ADDENDUM NO. 2

Reference: New Cedar City Liquor and Wine Store
Department of Alcoholic Beverage Control
DFCM Project No. 08227030

Addendum No. A02

New Cedar City, UT Liquor Store
Department of Alcoholic Beverage Control
Cedar City, Utah
DFCM Project No. 08227030

A 101

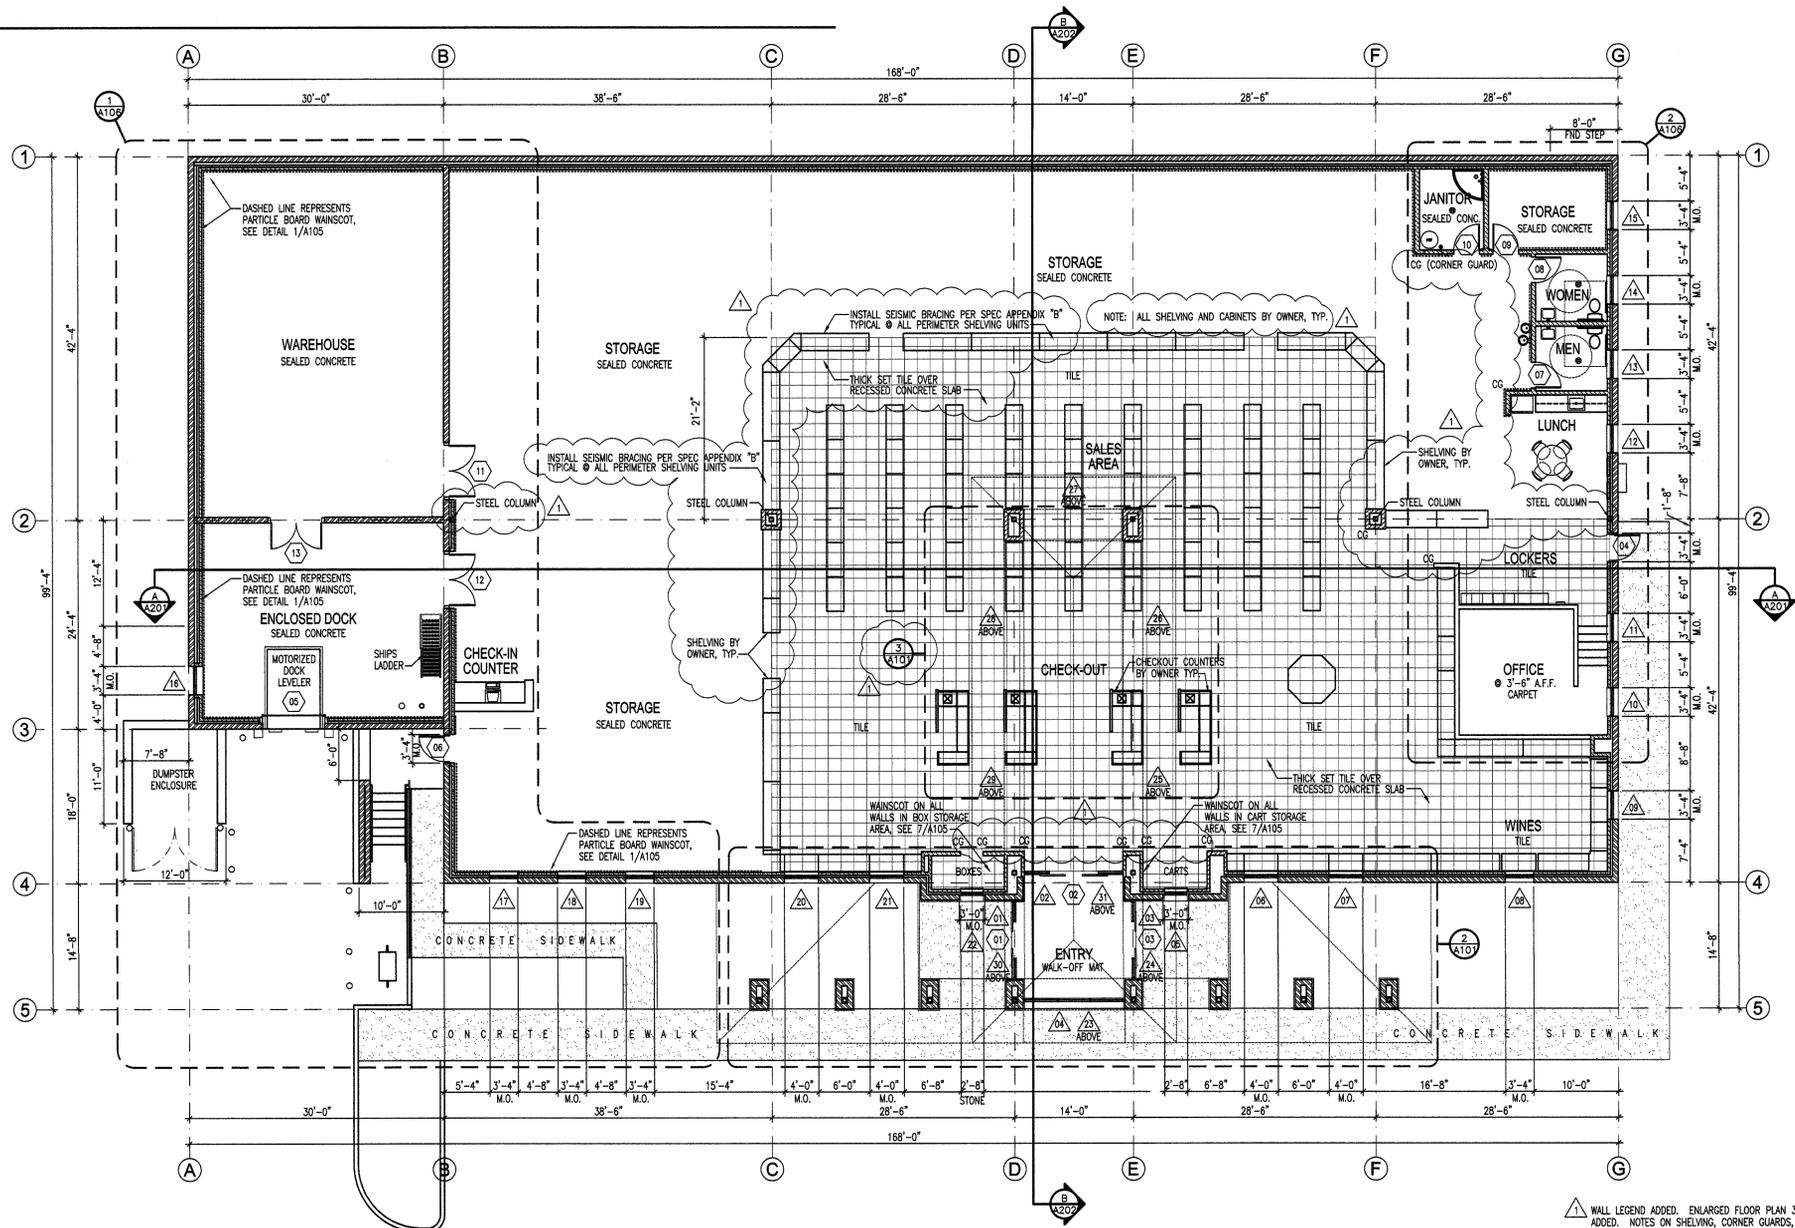
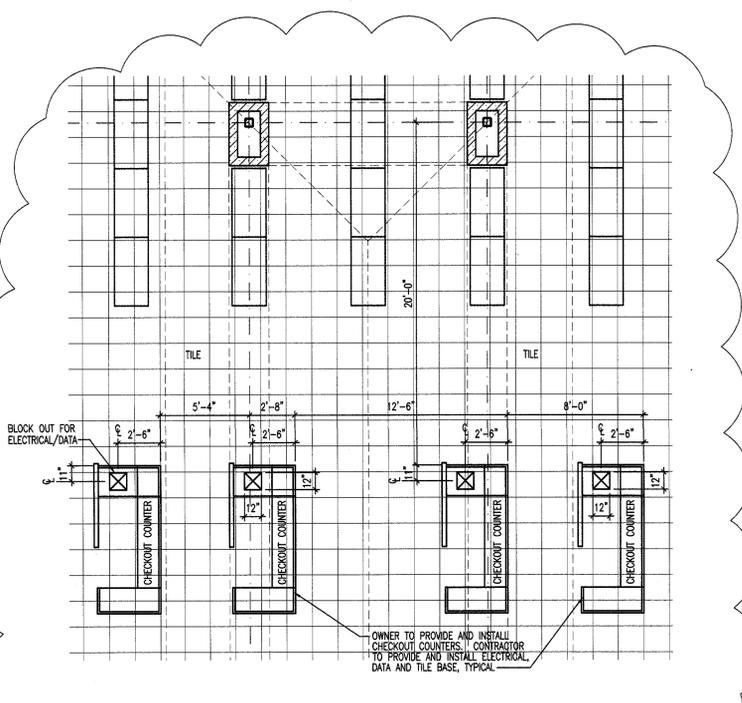
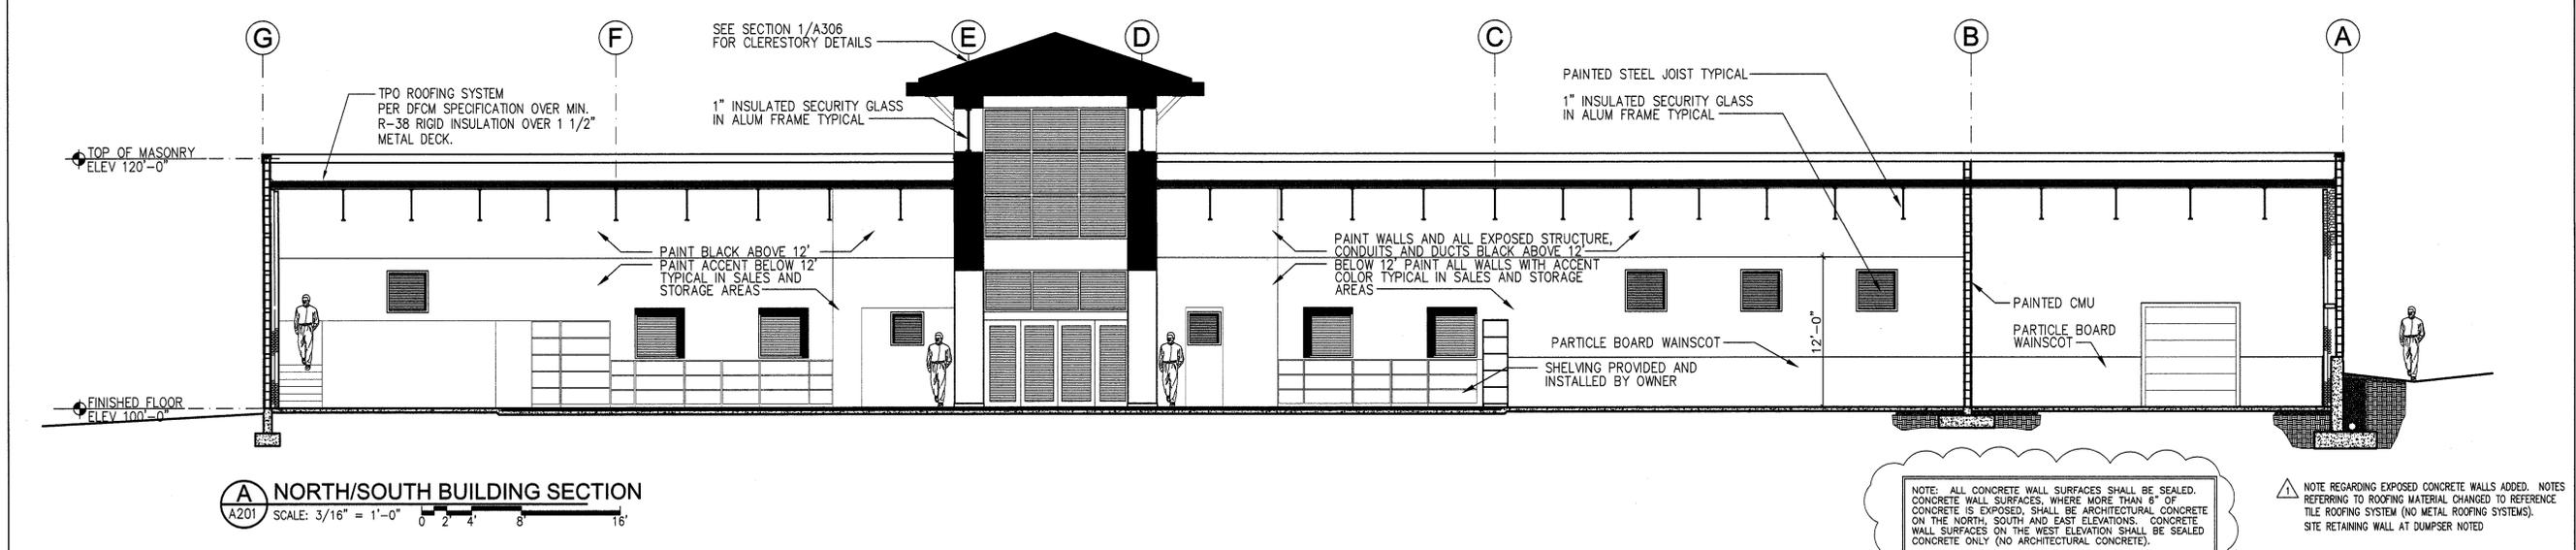
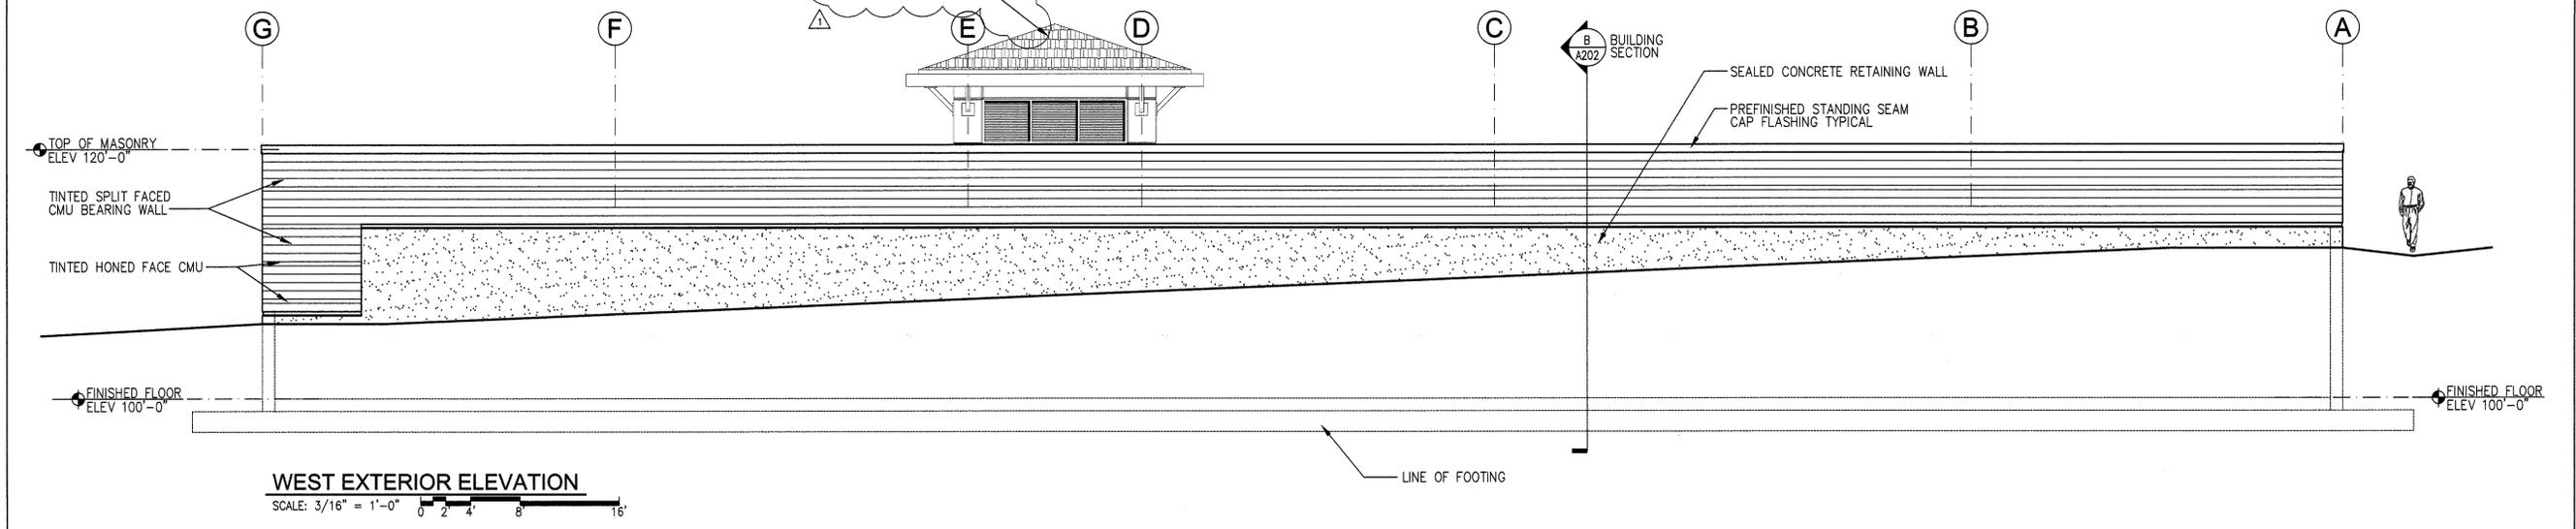
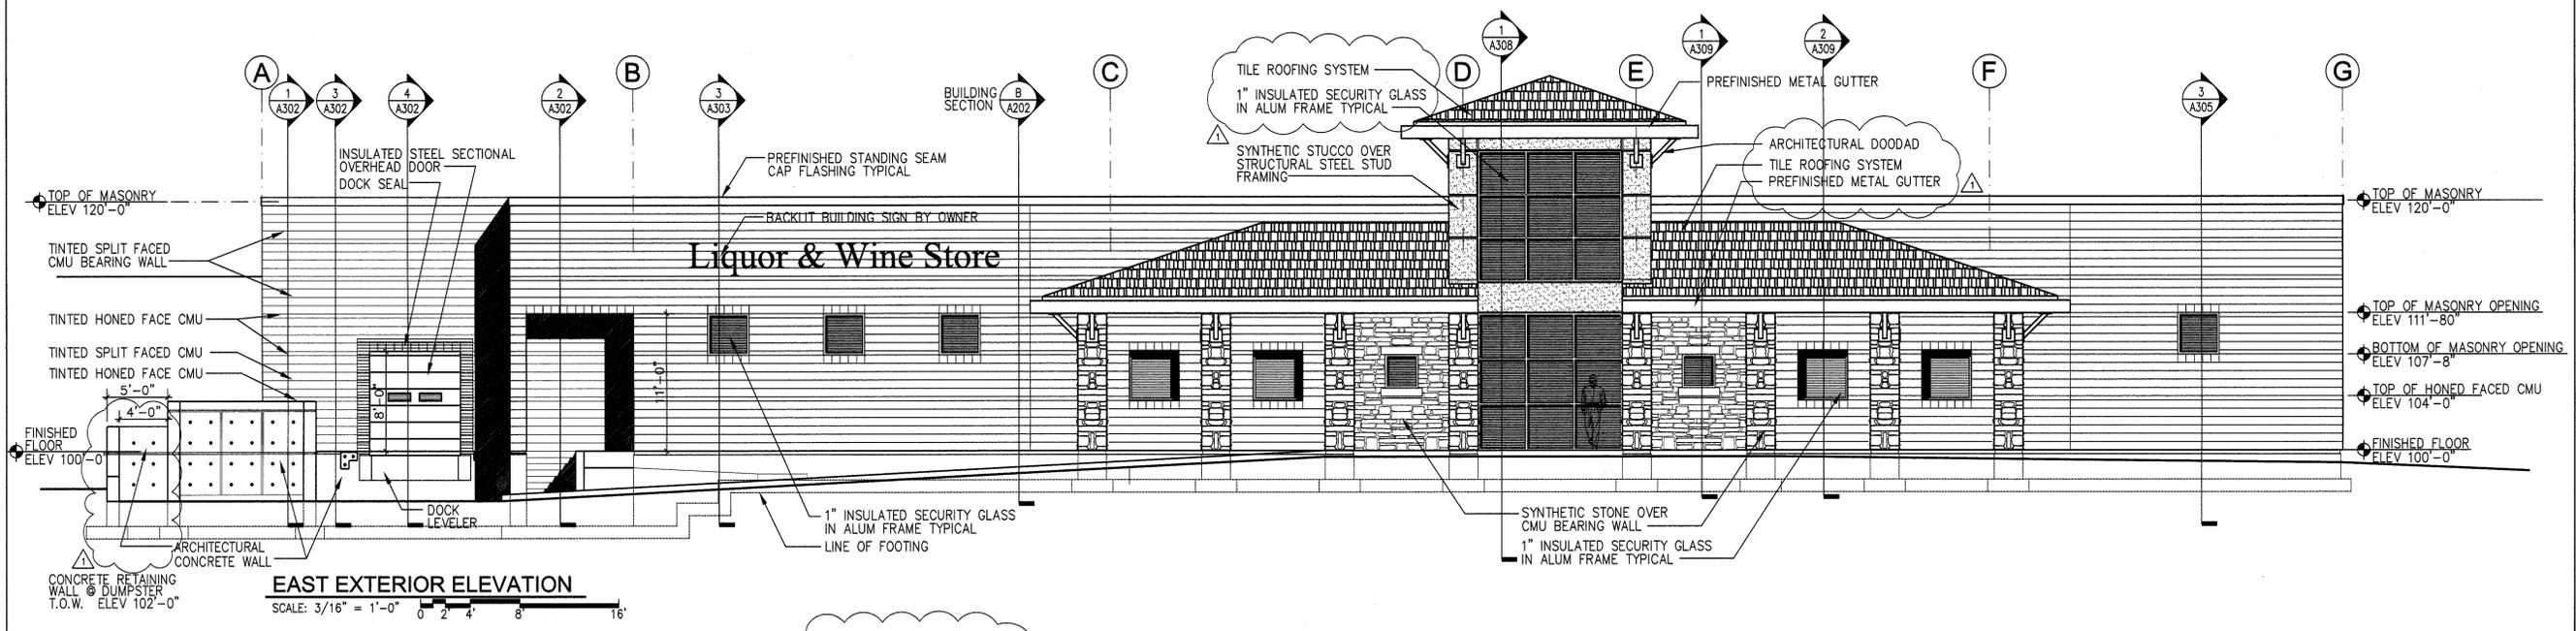
4. **Sheet A101: Sheet A101 is reissued with the following changes:**
 - a. A "Wall Legend" has been added to the sheet.
 - b. 3/A101, an enlarged floor plan at the checkout counters, has been added to the sheet and is referenced on 1/A101.
 - c. Additional notes have been added to 1/A101, including notes regarding shelving, seismic bracing for shelving, corner guards, floor tile and steel columns.

A
201

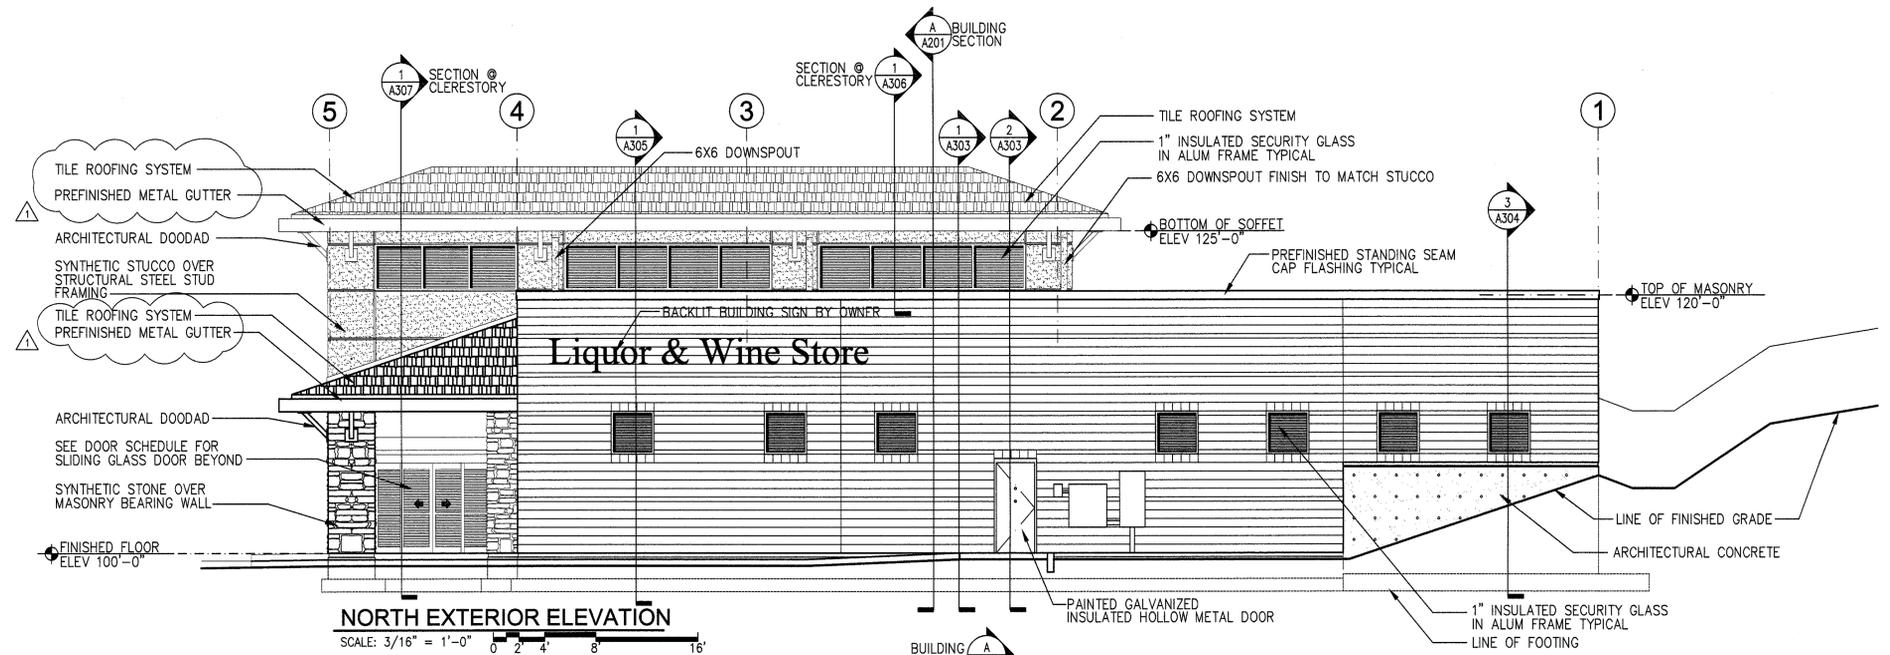
5. **Sheets A201 and A202 are reissued with the following changes:**
 - a. All elevations: All concrete wall surfaces shall be sealed.
 - b. North, South and East elevations: Concrete wall surfaces, where more than six inches (6") of concrete is exposed, shall be architectural concrete.
 - c. West elevation: Concrete wall surfaces shall be sealed concrete only (no architectural concrete).
 - d. Notes referring to types of roofing have been corrected and the references to metal roofing have been removed and tile roofing noted.
 - e. A note has been added defining the site retaining wall at the dumpster area.

1. On plan sheet A202 there are two roofing systems called out metal and tile. Please clarify.
ANSWER: This has been corrected on Sheets A201 and A202.
2. Is it correct that all utility connections will be paid for by the State and all we will be required to do is make the arrangements?

NOTE REGARDING EXPOSED CONCRETE WALLS ADDED. NOTES REFERRING TO ROOFING MATERIAL CHANGED TO REFERENCE TILE ROOFING SYSTEM (NO METAL ROOFING SYSTEMS). SITE RETAINING WALL AT DUMPSTER NOTED.
